CITY OF OREGON CITY

**CITY OF OREGON CITY
TYPE III – CONDITIONAL USE PERMIT AND
SITE PLAN & DESIGN REVIEW**

FILE NO.: CU 05-02 & SP 05-16

REQUEST: Conditional Use Permit and Site Plan and Design Review approval for the construction of a sanitary sewer lift station.

PROJECT NO. 05-0748-202 SCALE AS SHOWN DATE JULY 2005		SHEET AC-C1 11 of 50
CITY OF OREGON CITY SANITARY SEWAGE LIFT STATION REPLACEMENT PROJECT

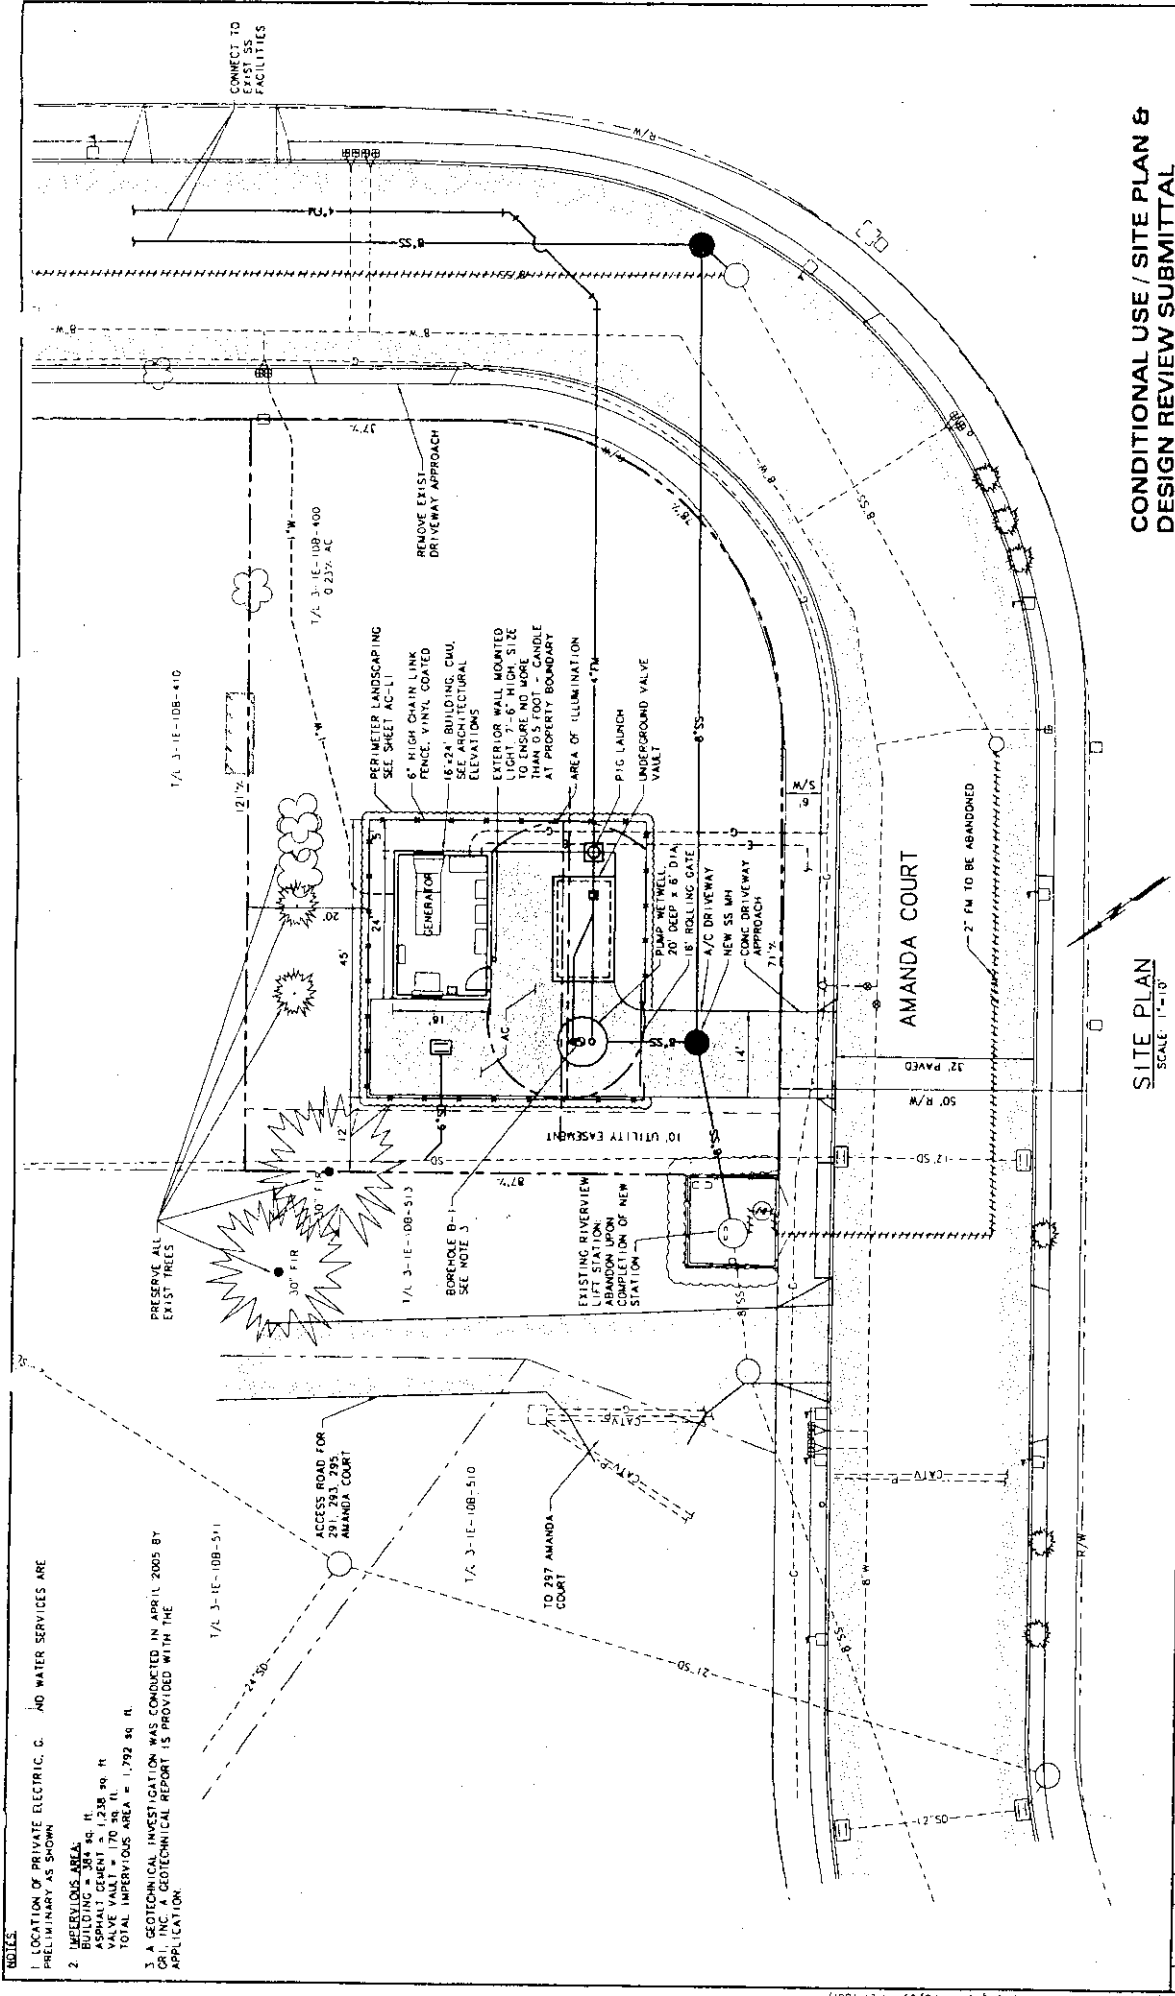
Finding: Complies as Proposed. The proposal includes 1,792 square feet of impervious surfaces, as displayed on sheet AC-C1. Any increase in impervious surface over 5,000 square feet requires detention and water quality control (OCMC 13.12.50). Stormwater from the building and impervious surfaces will be conveyed into an existing underground 12-inch storm sewer located in the western portion of the property. The direction of the stormwater into the 12-inch pipe will ensure that the drainage from the site will not degrade the water quality of the surrounding areas.
